# UNITED STATES PATENT AND TRADEMARK OFFICE

APPLICATION NO.	FILING DATE	FIRST NAMED INVENTOR	ATTORNEY DOCKET NO.	CONFIRMATION NO.
10/692,707	10/24/2003	Kenny K. Chinn	AB-123U1 / 585-0026US-C	9782
70573	7590	07/11/2007	EXAMINER	
Wong, Cabello, Lutsch, Rutherford & Bruckler L.L.P			CAZAN, LIVIUS RADU	
20333 SH 249			ART UNIT	PAPER NUMBER
Suite 600				3729
Houston, TX 77070				
			MAIL DATE	DELIVERY MODE
			07/11/2007	PAPER

<b>Office Action Summary</b>	<b>Application No.</b>	<b>Applicant(s)</b>	
	10/692,707	CHINN ET AL.	
	<b>Examiner</b>	<b>Art Unit</b>	
	Livius R. Cazan	3729

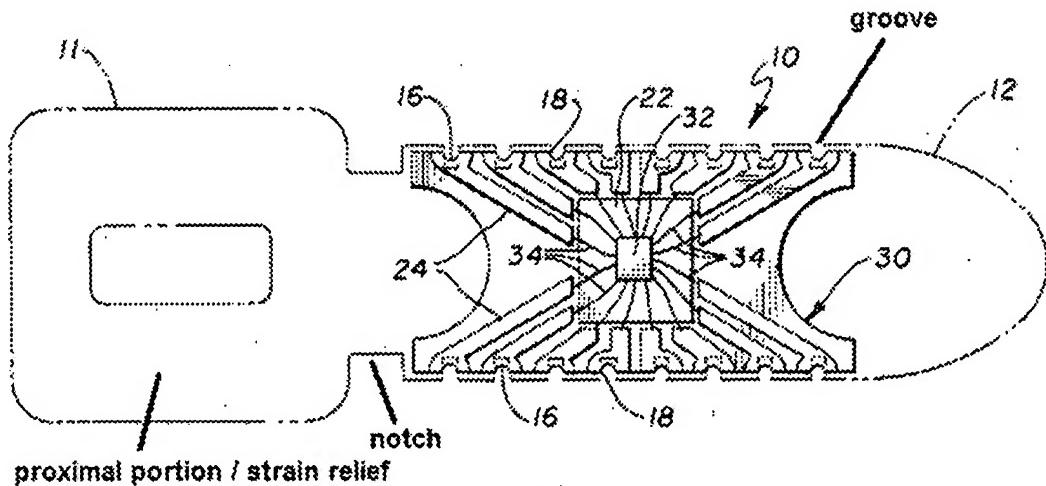
**Regarding claims 7 and 8,** at least one groove (18, Fig. 9) and one notch are formed in the pin (see figure below).

**Regarding claims 10 and 11,** the pin includes a proximal portion and a distal portion, the proximal portion including a means for securely holding the pin and a strain relief (see image above). In particular, the increased height of the proximal portion allows for strain relief during rotation of the connector pin and allows for easier holding of the pin.
